PC2000078: Private Plan Change Request to the Operative District Plan from Urban Estates Limited in South-East Rolleston - Request for further information

Thank you for your application lodged on behalf of Urban Estates Limited requesting a change to the Operative Selwyn District Plan. In accordance with Clause 23 of Schedule 1 of the Resource Management Act 1991 (the 'RMA'), the following information is requested to enable Council to better evaluate the potential effects of the proposal, the ways in which adverse effects may be mitigated and the nature of consultation undertaken.

Figure 1: Rolleston Structure Plan, September 2009⁷

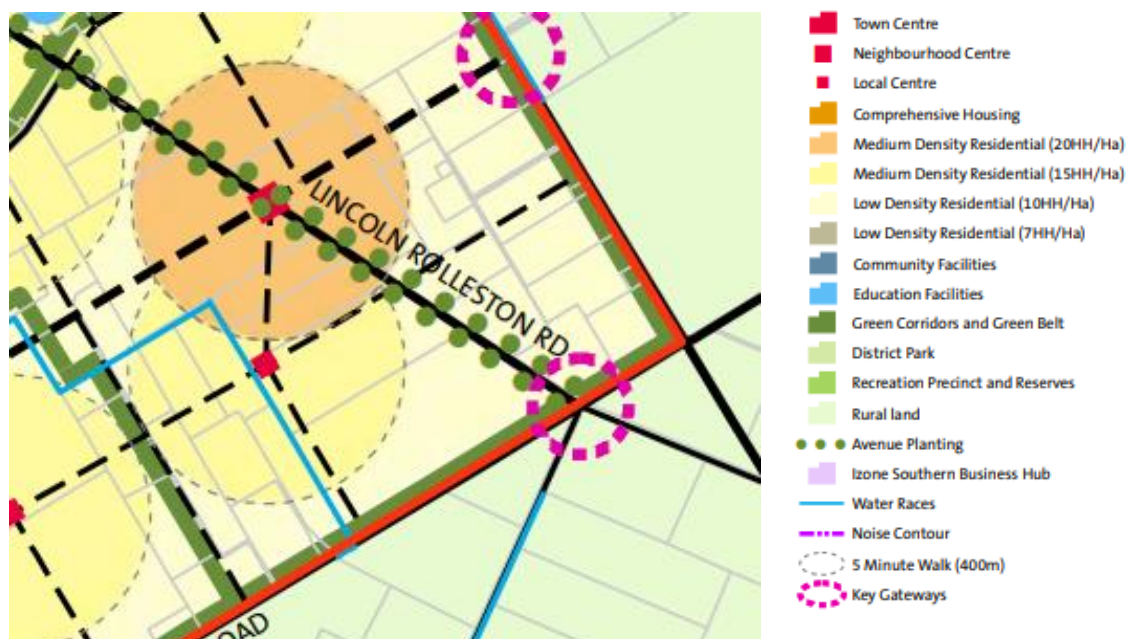
22. The RSP illustrates several features that do not appear to have been factored into the ODP, including “*avenue planting*” along the Lincoln-Rolleston Road boundary and “*green corridors and green belt*” along the Selwyn Road interface (refer to **Figure 1**). Please provide an assessment of

how these design features have been factored into the ODP, including consideration of how other zoned changes and the Special Housing Areas have implemented these aspects of the RSP.

23. The RSP indicates that a Local Centre is anticipated in the SR13 area to support the future local retail needs of the community in this area (refer to **Figure 1**). The ODP does not make any provision for this Local Centre to compliment the commercial centre hierarchy in Selwyn 2031, the Operative District Plan and the CRPS. Commercial centres are also a focal point for higher density housing, as illustrated in the RSP. Please provide an assessment documenting the rationale for why provision has not been made for a Local Centre in the general location identified in the RSP and what implication this may have on housing densities and the ability for future residents to access their local retail and service needs.
